**COMMITTEE OF THE WHOLE JUNE 20, 2005**

**SITE DEVELOPMENT FILE DA.05.015**  
**LORWOOD HOLDINGS INC.**

**Site Plan**

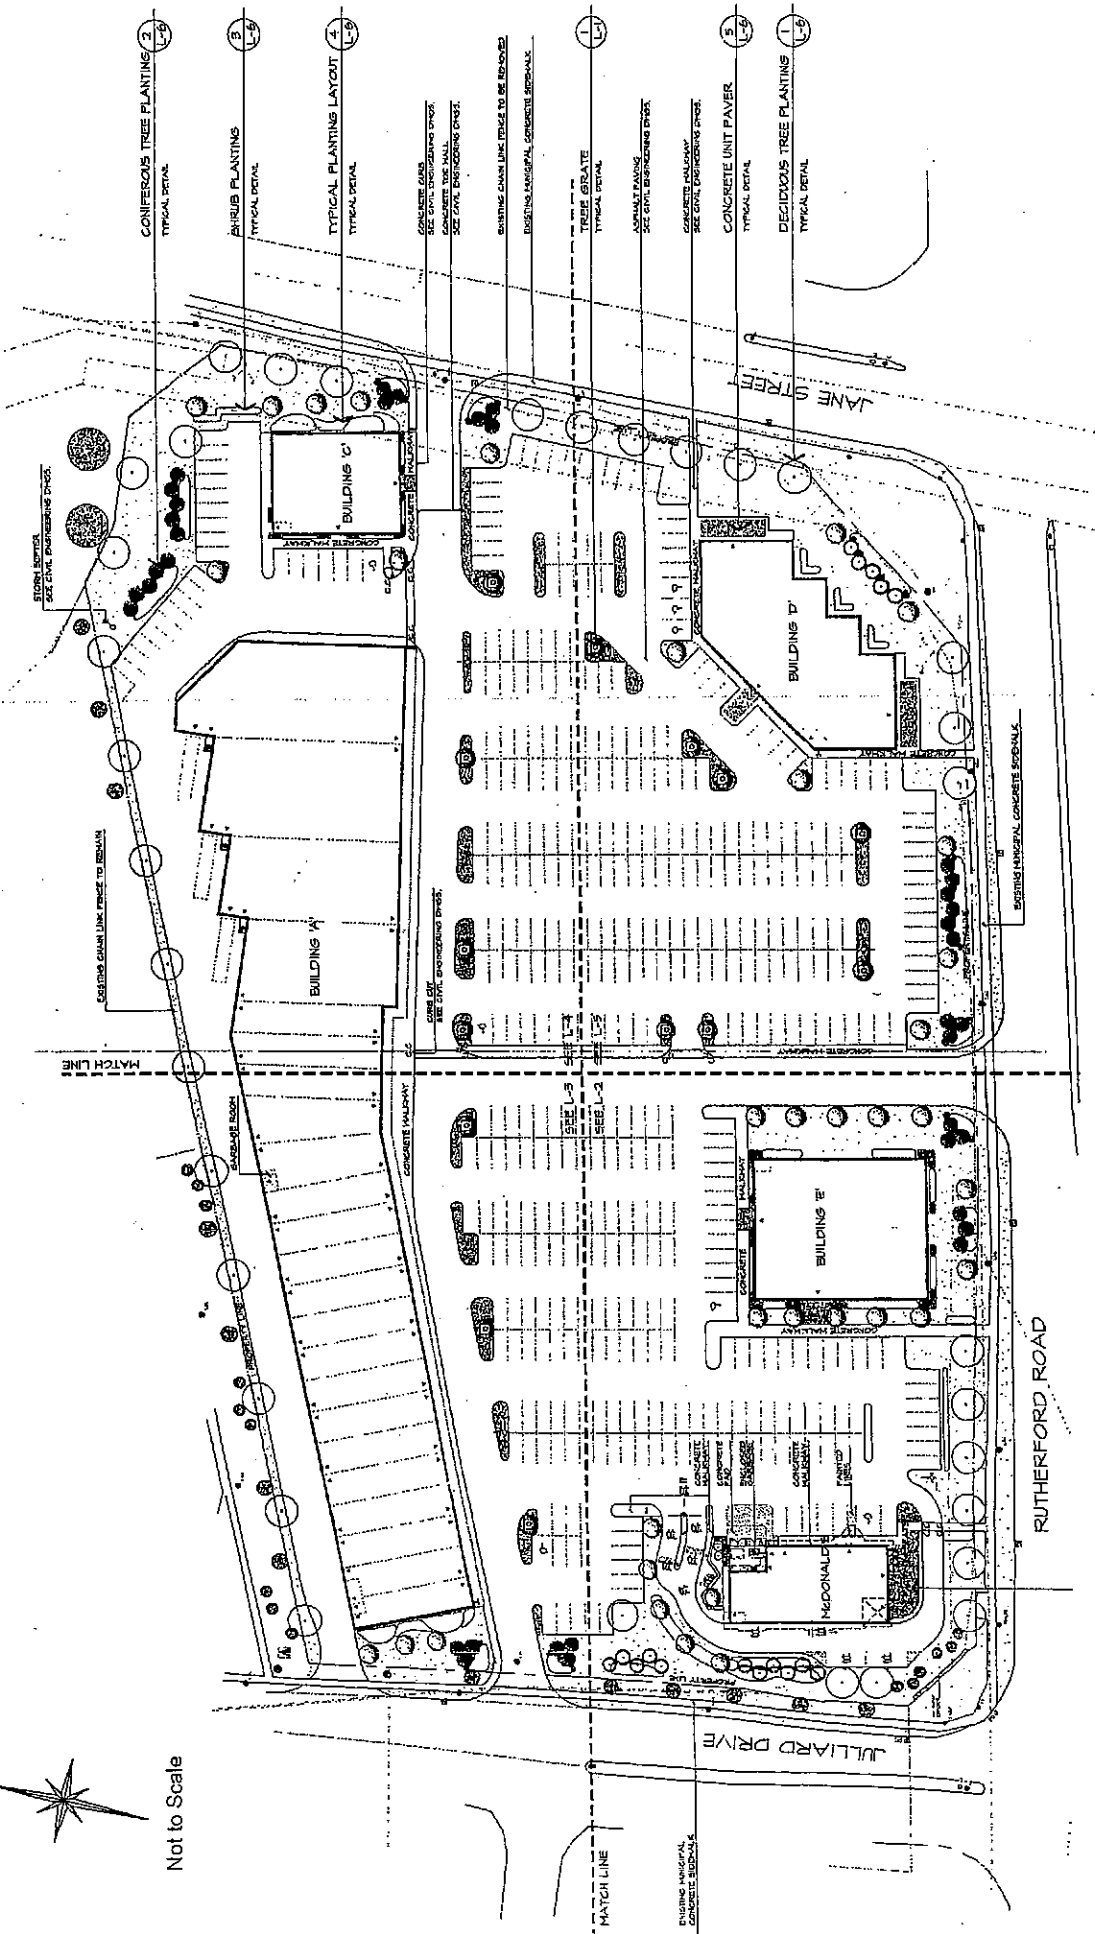
Through the review of the site plan, an additional zoning exception has been identified for Building "A," respecting the minimum exterior sideyard abutting Julliard Drive. The minimum required exterior sideyard is 9.0m, whereas 6.7m has been provided abutting Building 'A' as shown on Attachment #2. The minimum required landscape strip width abutting a street is 6m, and therefore the proposed 6.7m setback that is comprised of landscaping can be supported.

The site plan shows one drive-through on the west side of the McDonald's building and abutting Rutherford Road. The main stacking area will be at the rear (north) of the building with the pick-up windows at the side abutting Julliard Drive. Landscaping will be provided within the 6.0m wide landscaping strip to screen the drive-through. None of the remaining buildings include a drive-through.

Three driveway access points are proposed to the site including a right-in/right-out on each of Rutherford Road and Jane Street, and a full-movement driveway on Julliard Drive. Currently, the site plan depicts full-movement driveways from Rutherford Road and Jane Street, however, the Region of York has advised that only a right-in/right-out access will be approved. The Owner must revise the final site plan to comply with the Region's requirement. The loading areas for the larger multi-unit building are located on the north side of the building and are screened from Jane Street. All garbage areas will be incorporated within each building.

Staff is satisfied with the site layout for Buildings 'A' and 'B', subject to the comments in this report being addressed. The Owner will be required to submit a subsequent site plan application for Buildings 'C', 'D' and 'E' for approval by Council at a future date.
